# UNITED STATES PATENT AND TRADEMARK OFFICE

10/625,997

Dale W. Petty

## DETAILED ACTION

**FIG. 7**

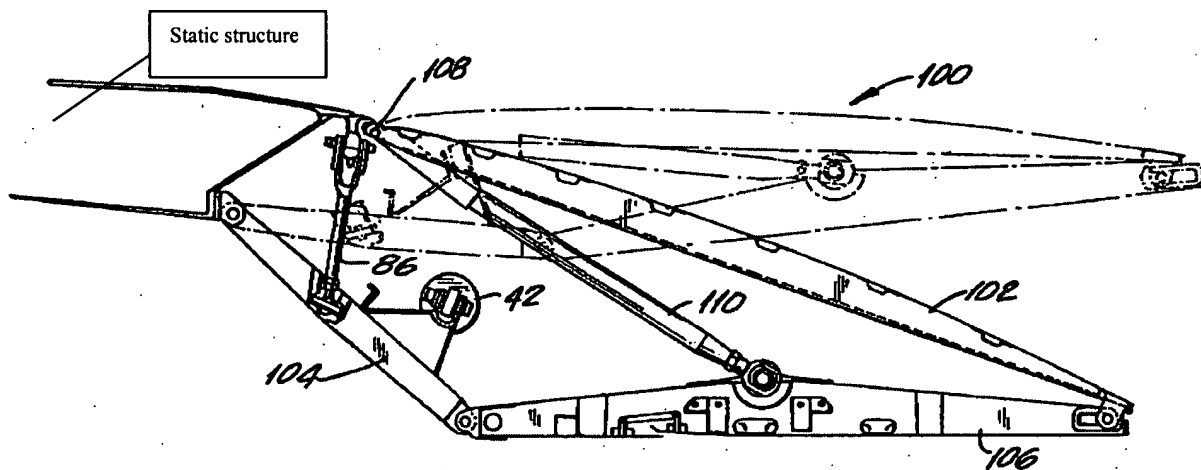
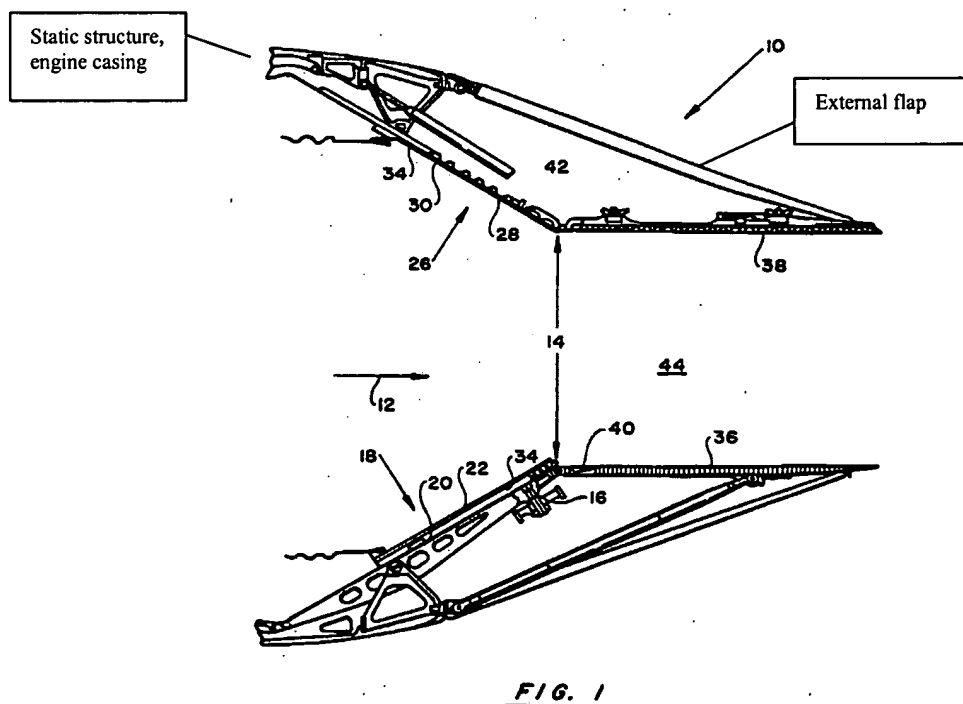
Nash teaches a turbine engine nozzle comprising: a static structure; a plurality of flap subassemblies arranged about an engine centerline comprising: an upstream flap 104; a downstream flap 106 pivotally coupled to the upstream flap for relative rotation about a hinge axis; an external flap 102 and an actuator linkage 110 couple to the downstream flap along a forward half thereof for actuating the upstream and downstream flaps so that the throat area is varied within a range of areas (min. and max. areas). See particularly cl. 5 ll. 28-30 and Figure 7.
